A-07-3101  
A

PLOT NO.131

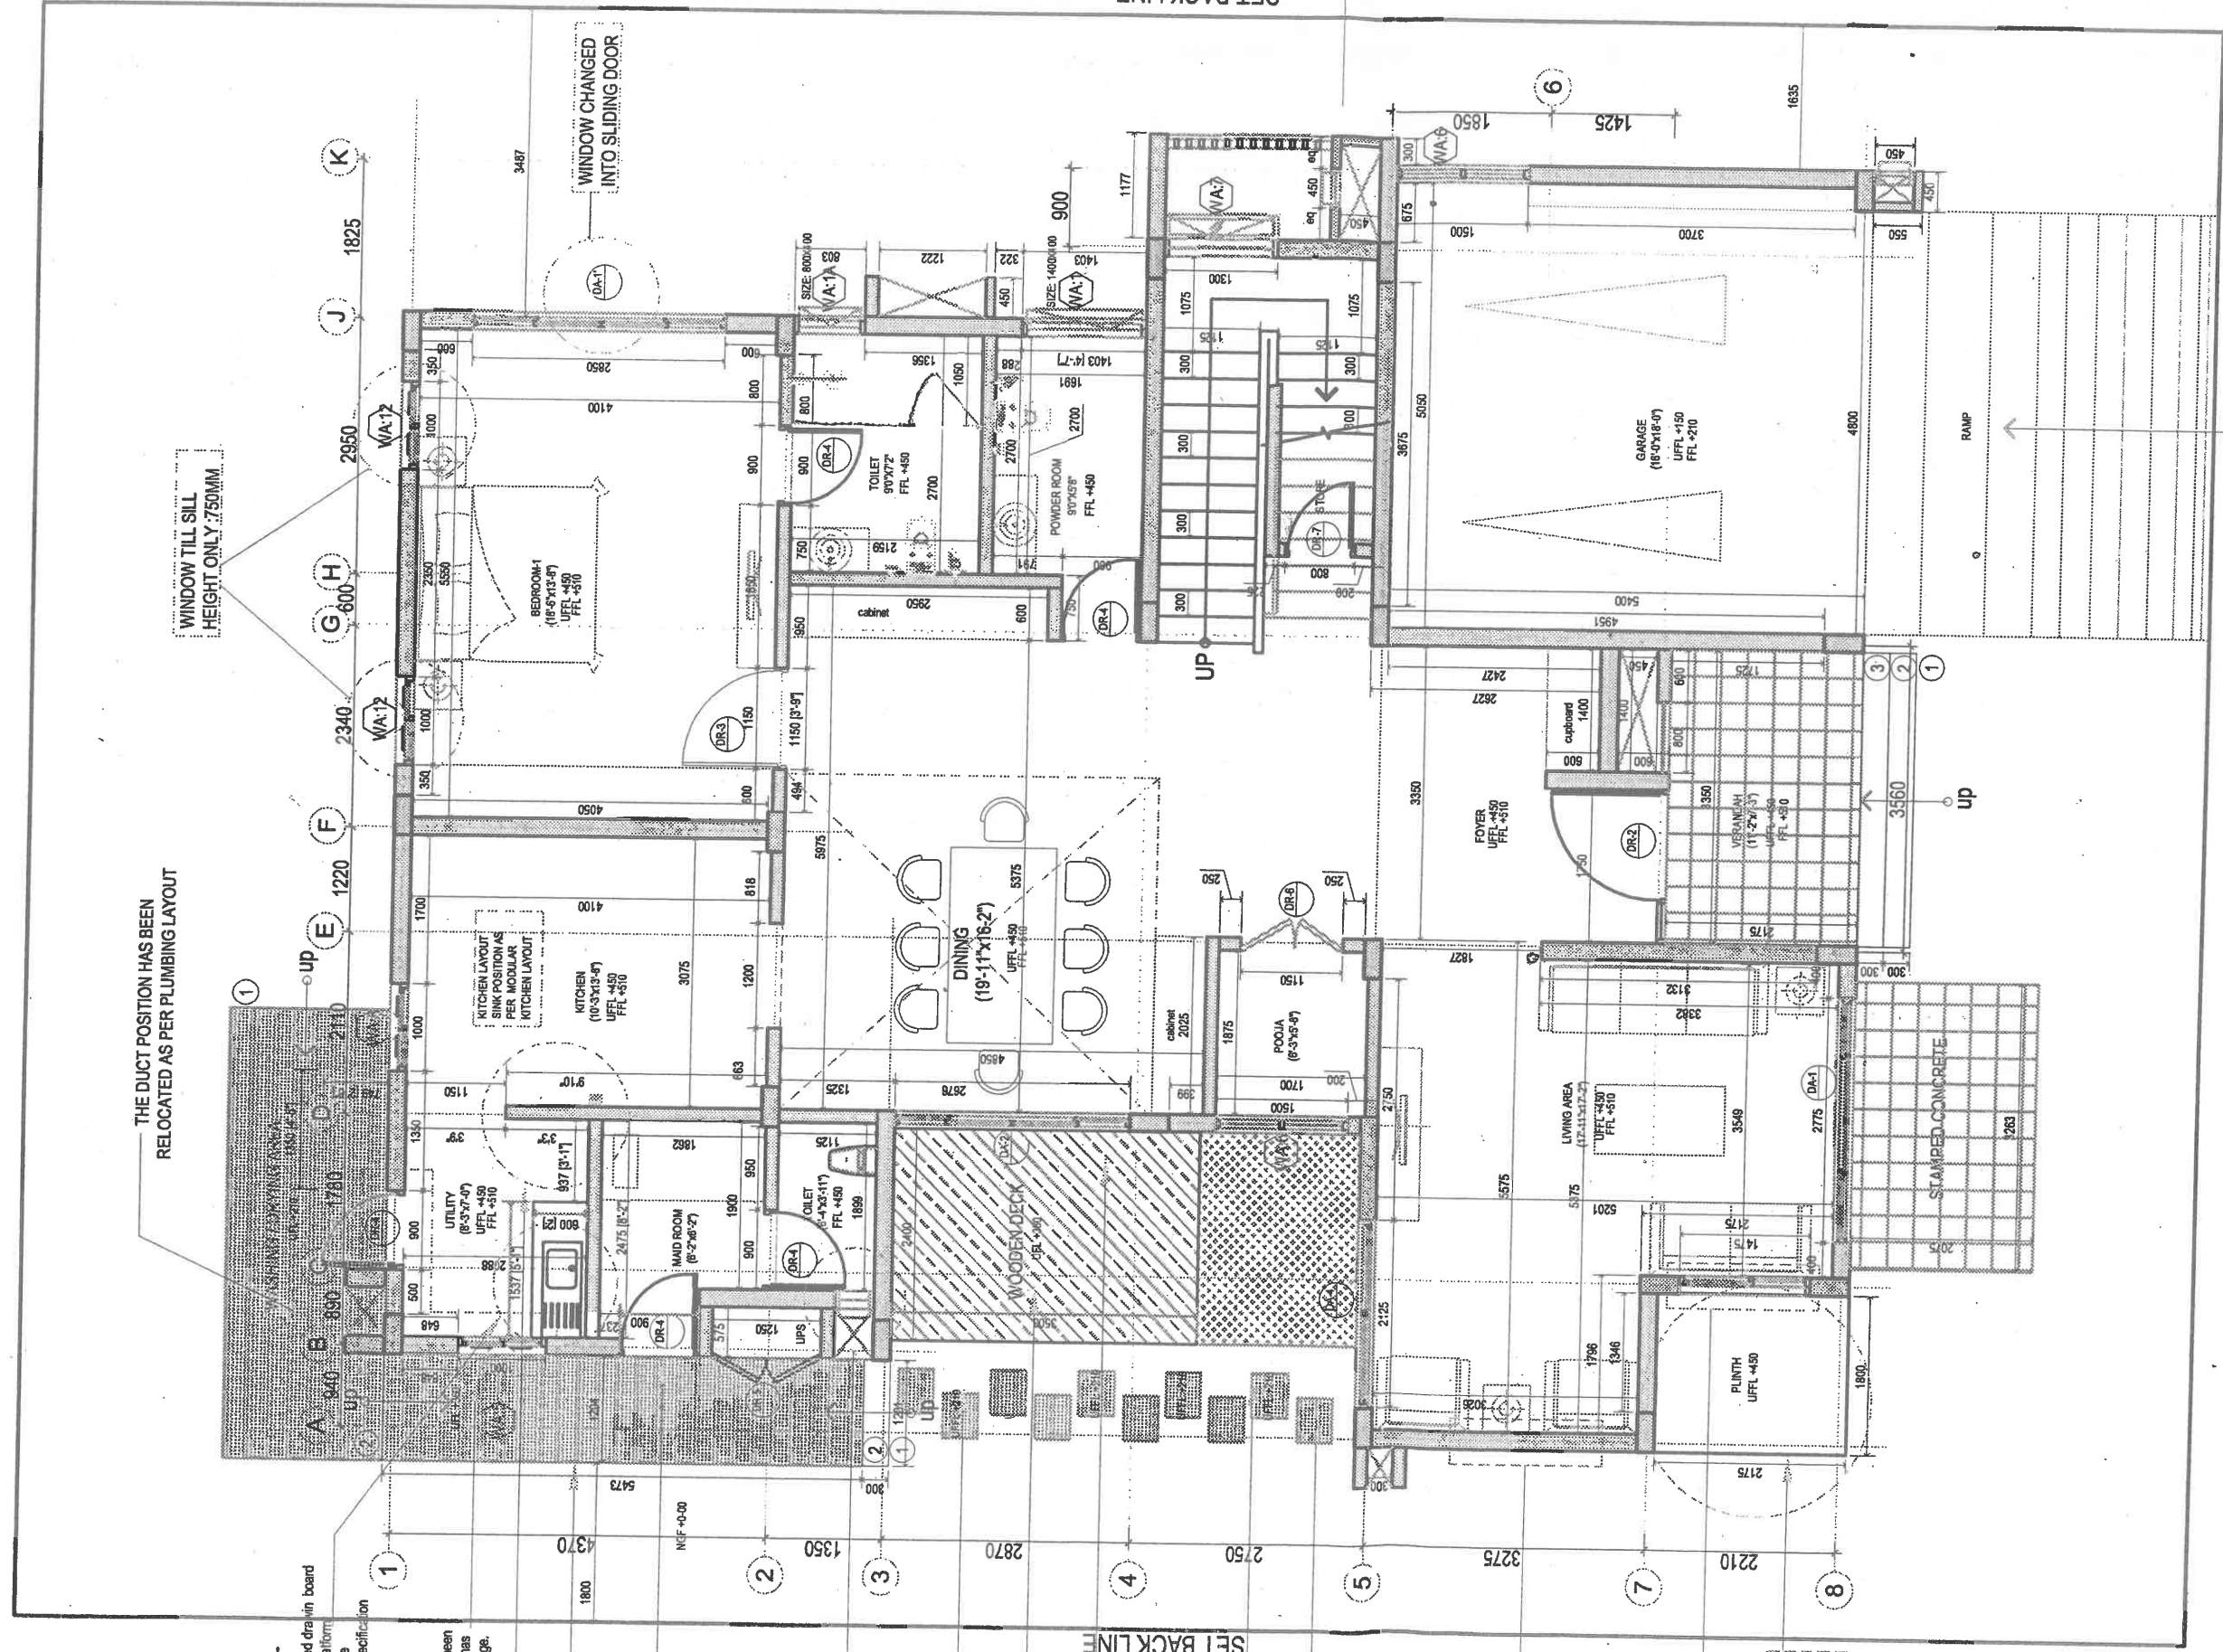
single bowl with 1/2" oriented drain board  
and additional platform  
size and type  
as per customers specification

DR-4 and WA-5 position has been  
changed and the wall length has  
been revised as per the change.

Wall extended

provision of 39"x20"  
ventilator  
along the full wall,  
starting at lintel height

VENTILATOR TILL  
HALF HEIGHT

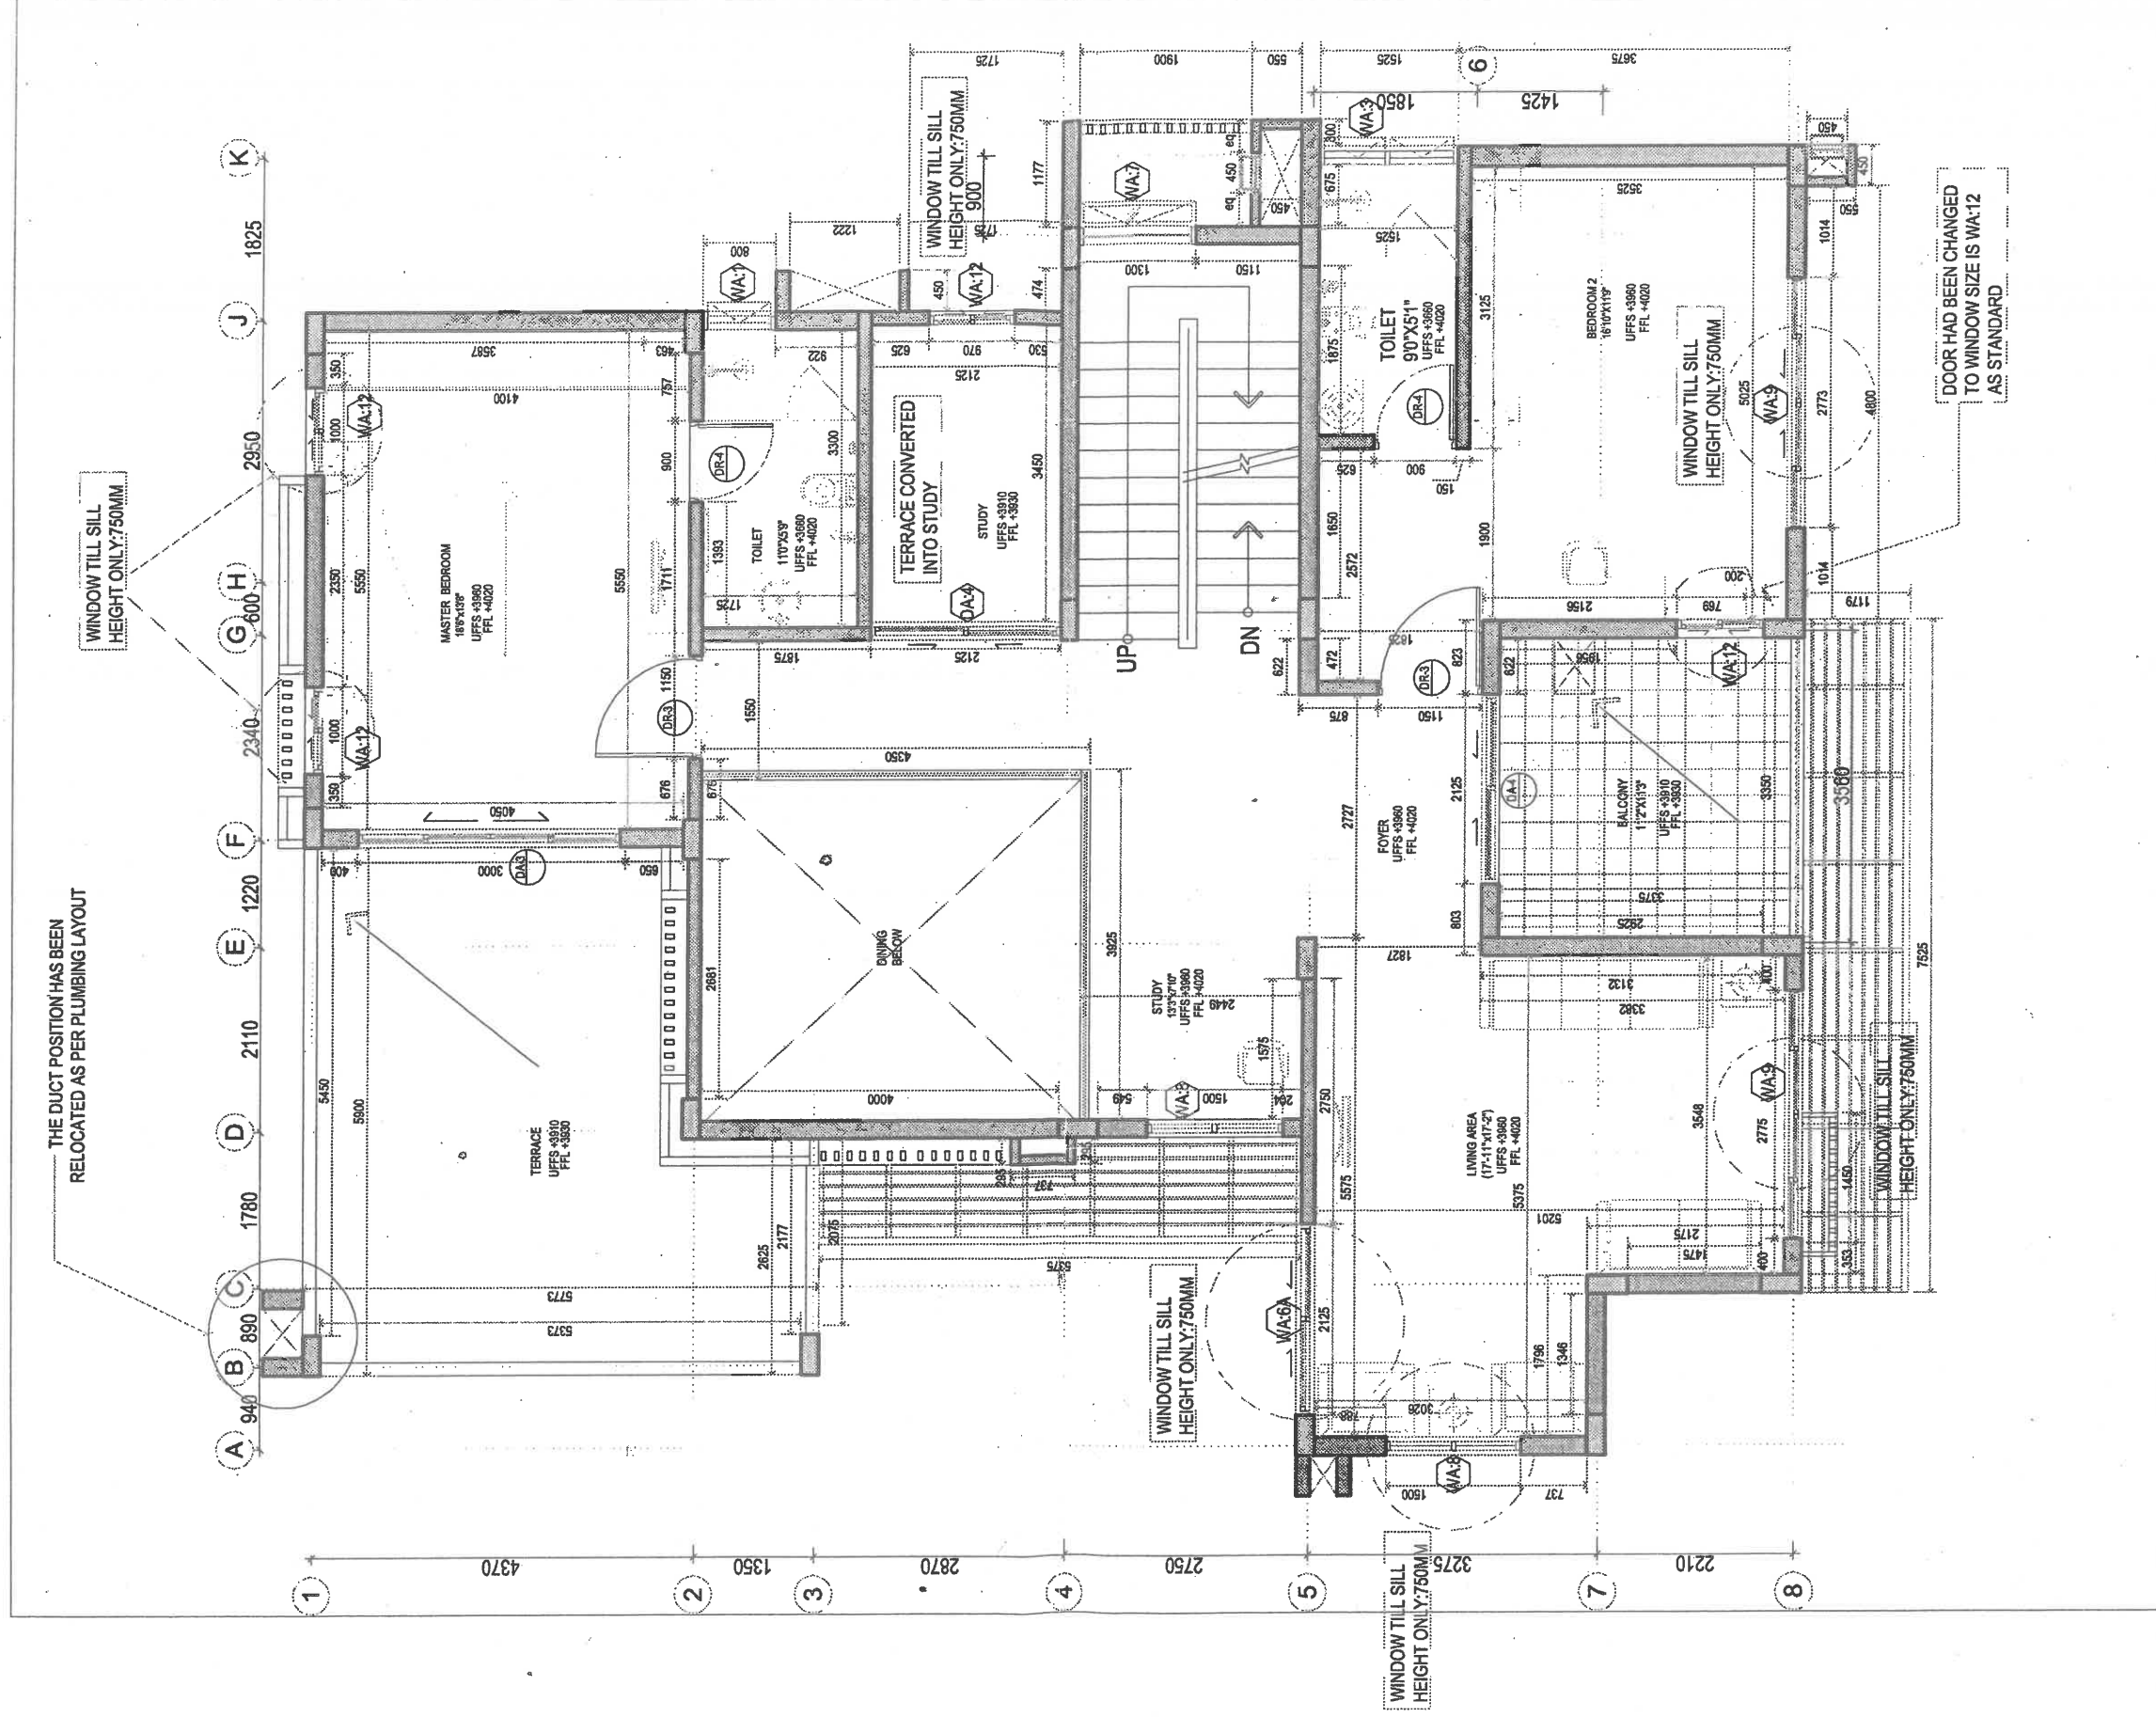
WINDOW TO BE  
BLOCKED

XED GLASS WINDOW  
LL 750MM

STAMP CONCRETE  
FLOORING  
AND METAL PERGOLA
